# UNITED STATES PATENT AND TRADEMARK OFFICE

APPLICATION NO.	FILING DATE	FIRST NAMED INVENTOR	ATTORNEY DOCKET NO.	CONFIRMATION NO.
10/567,046	05/05/2008	Johann Guelich	015258-066500US	2410
20350 7590 08/09/2011 KILPATRICK TOWNSEND & STOCKTON LLP TWO EMBARCADERO CENTER EIGHTH FLOOR SAN FRANCISCO, CA 94111-3834			EXAMINER MCDOWELL, LIAM J	
			ART UNIT 3745	PAPER NUMBER
			NOTIFICATION DATE 08/09/2011	DELIVERY MODE ELECTRONIC

<b>Office Action Summary</b>	<b>Application No.</b> 10/567,046	<b>Applicant(s)</b> GUELICH, JOHANN	
	<b>Examiner</b> LIAM MCDOWELL	<b>Art Unit</b> 3745

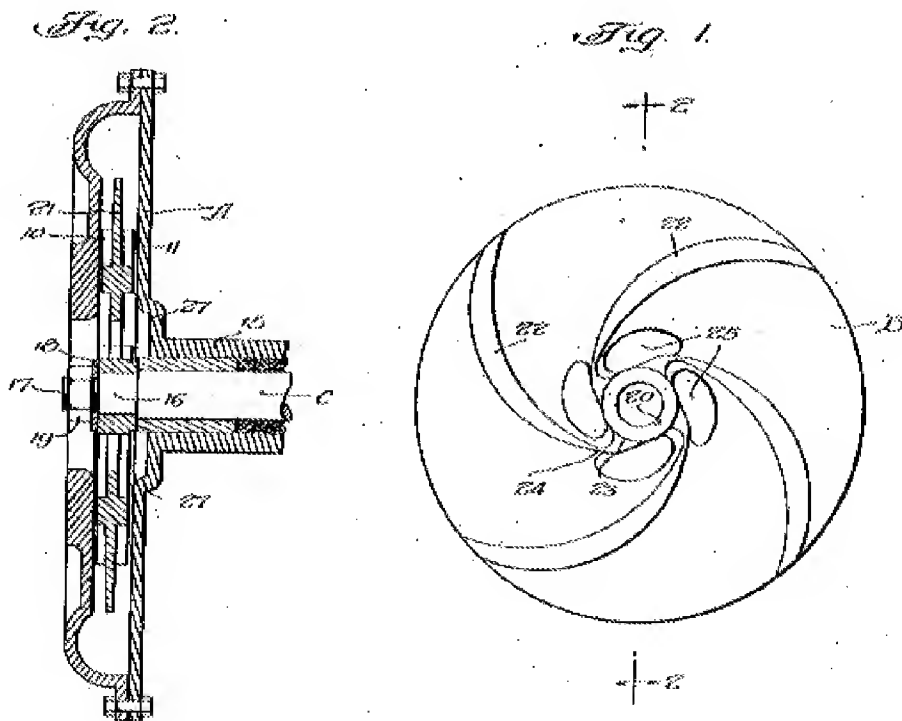
Vitu discloses with respect to Figs. 1 and 2 reproduced below, an impeller for pumps, in particular radial pumps, said pump including one or more vanes (22), characterised in that the impeller (B) additionally includes an intermediate wall (21) at which one or more vanes (22) are provided on both sides (see page 1, lines 82-85), and in that at least one passage opening (25) is formed in the intermediate wall (21) in order to distribute a desired pump flow to the vanes (22) on both sides of the intermediate wall. See page 2, lines 45-52.

Vitu discloses the impeller in accordance with claim 1 (as discussed above) wherein the impeller (B) has a suction side (10) which is directed towards a suction opening 13 of the pump, wherein the vanes (22) are connected on the side (11) of the intermediate wall (21) directed away from the suction side to the suction side (10) via the at least one passage opening (25). See Fig. 2.

Vitu discloses the impeller in accordance with claim 1 (as discussed above) wherein the impeller (B) has a hub (15) and wherein a plurality of passage openings (25) are formed in a region of the impeller (B) adjacent to the hub (15). See Fig. 1.

Vitu discloses the impeller in accordance with claim 1 (as discussed above) wherein the impeller (B) is open towards the suction side (11) or towards both sides (10, 11) (see Fig. 2), and/or wherein the vanes (22) additionally include shortened vanes, so-called splitter vanes. Vitu discloses that the impeller is open. The term “and/or” includes “or” and thus, the second limitation of the shortened vanes is an alternative that need not be met in order for Vitu to anticipate claim 4 in its present form.
